# STAFF RECOMMENDATION

NCPC File No. Z.C. 94-01A

## AMENDMENT TO APPROVED PLANNED UNIT DEVELOPMENT 1331 L Street NW, Square 247 Washington, D.C.

Submitted by the Zoning Commission of the District of Columbia

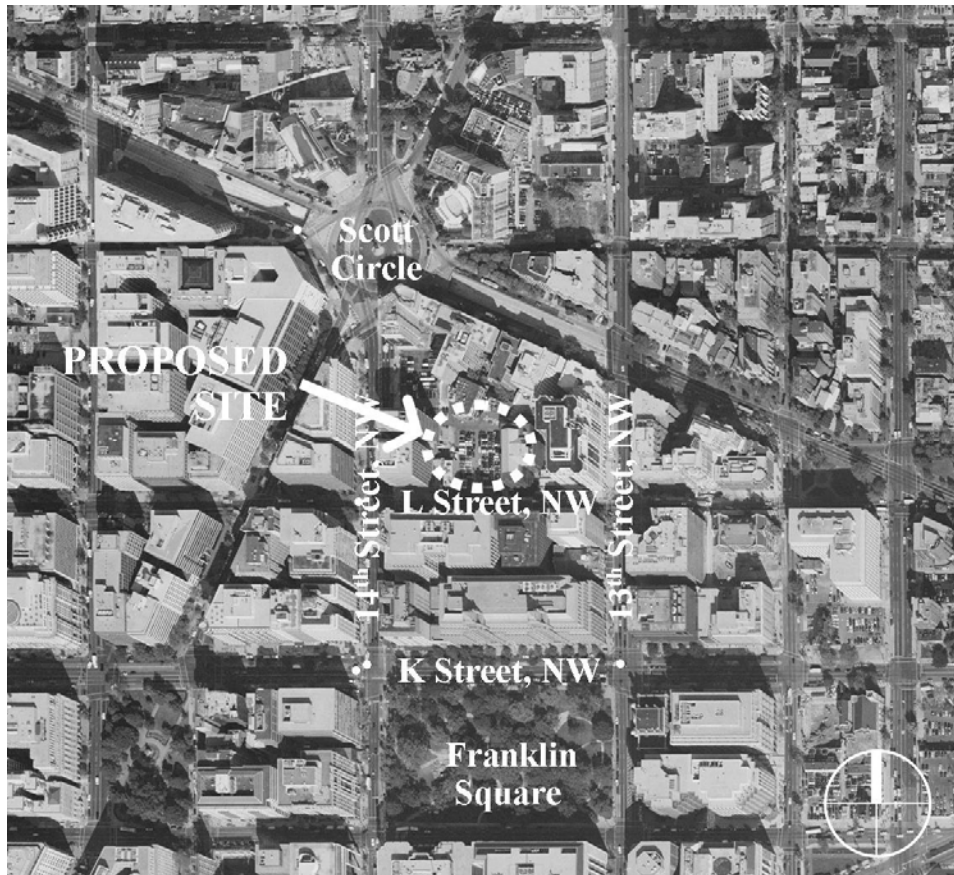
**Advises** that according to NCPC’s interpretation of the Height of Building Act of 1910, the horizontal metal canopy element is in conflict with Section 5 of the Act, which authorizes vertical elements such as “spires, towers, domes, minarets, pinnacles” in excess of the allowable

building height; and that the glass guardrail at the edge of the roof is the functional equivalent of a parapet for the purposes of Section 7 of the Act, which states that “no parapet walls shall extend above the limit of height,”

**Recommends** that the Zoning Commission exercise its discretion to require the applicant to modify the design to eliminate the canopy and guardrail, or set back these elements from the exterior walls to distances equal to their respective heights above the adjacent roof.

**REVISED PROPOSED SOUTH ELEVATION**

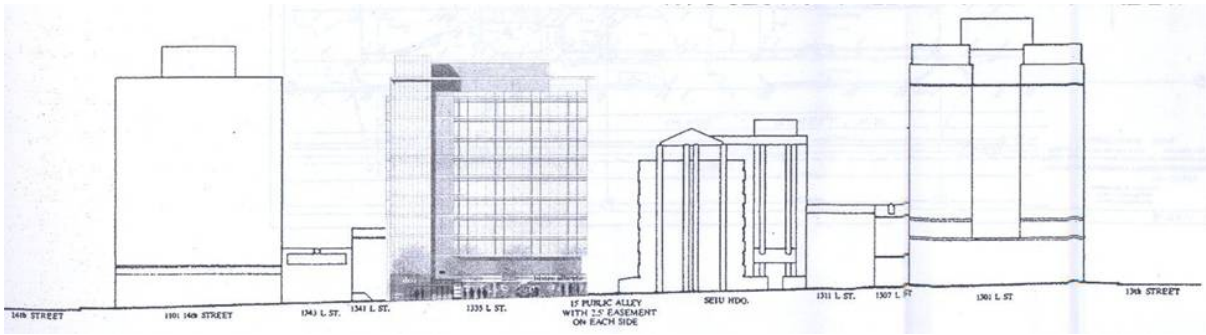
While they may be permitted under District interpretation of its own Zoning Regulations, staff finds that the glass railing and canopy element are in conflict with the federal Height of Buildings Act of 1910.

Section 7 of the Height Act states that no parapet walls shall extend above the limit of height. As defined in Sturgis' *Dictionary of Architecture and Building*, a parapet is "a dwarf wall or barrier built on the edge of a terrace, platform, bridge, balcony, or other elevated place, as a protection against falling." By this definition, the guardrail is clearly functioning as a parapet and is therefore prohibited under the Height Act. If the guardrail were set back from the edge or the roof, however, it would not meet this definition of a parapet and would be allowable.

Section 5 of the Height Act states that spires, towers, domes, minarets and pinnacles may be erected to a greater height than any limit prescribed in the Act. These terms all describe vertical elements that project above the roof. The canopy element is horizontal, not vertical, and is therefore not included among the elements allowed by the Height Act. It also repeats the rhythm established by the horizontal spandrels on the façade, thereby creating the visual effect of another floor.

Staff therefore recommends that the Zoning Commission exercise its discretion to require the applicant to modify the design to eliminate the canopy and guardrail, or set back these elements from the exterior walls to distances equal to their respective heights above the adjacent roof.
